SOIL/SITE EVALUATION for ON-SITE WASTEWATER SYSTEM

PLAN APPROVAL
DISTRICT R20 USE SFD
#BEDROOMS 3
12/2/05 Pte

Lot 47 Stone Cross

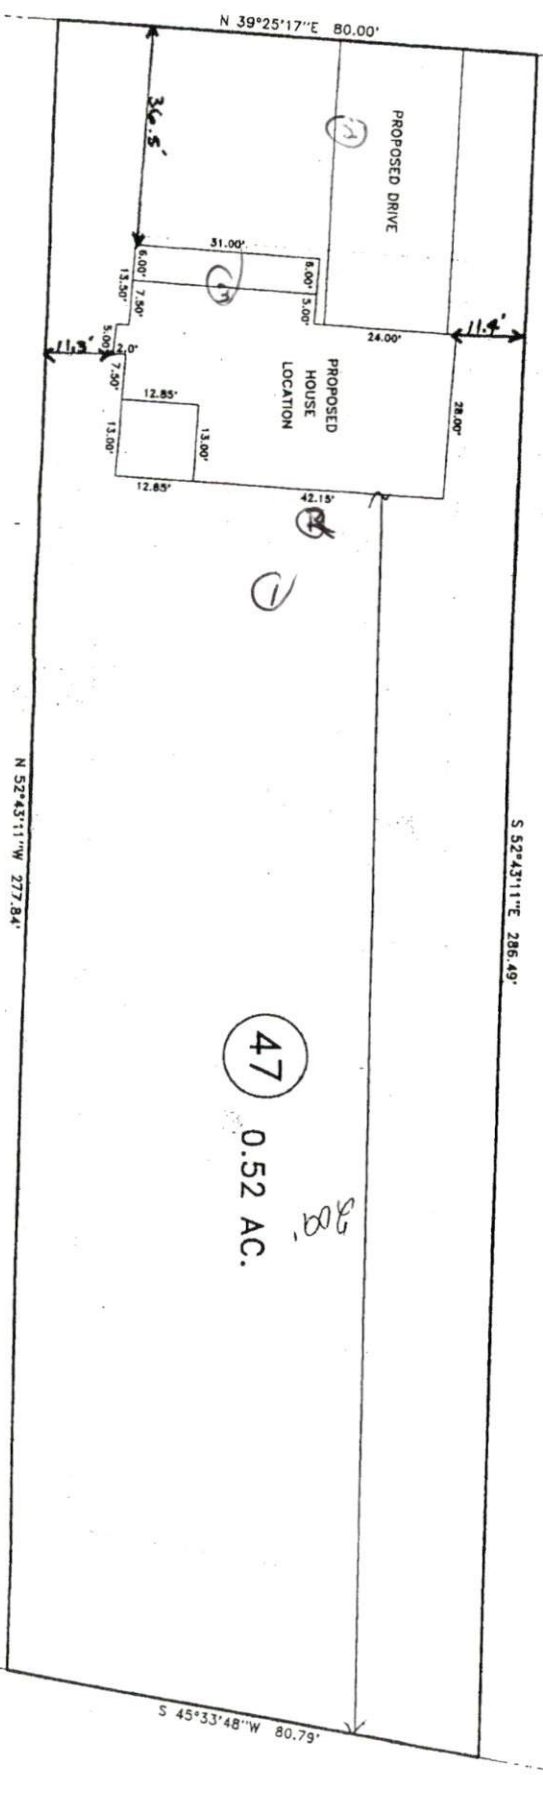
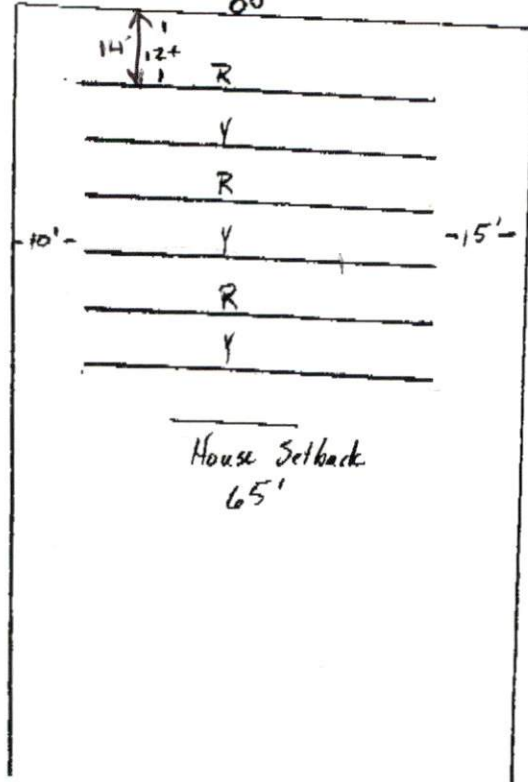
• MOVE HOUSE
TO 70'
FROM FRONT PL
15' DRIVE ON
LEFT SIDE OF (PALING HOUSE)
PROPERTY.
IF FRONT ENTRANCE
GARAGE HOUSE MUST
BE MOVED BACK
FURTHER TO ALLOW
ROOM FOR DRIVE

✓ Accepted System 25% Reduction
Initial - 180'

✓ PPBTS Repair 50% Reduction
120'

Total 300'

PPBTS Initial + Repair
120' + 120' = 240'

135' & 135' = 270'
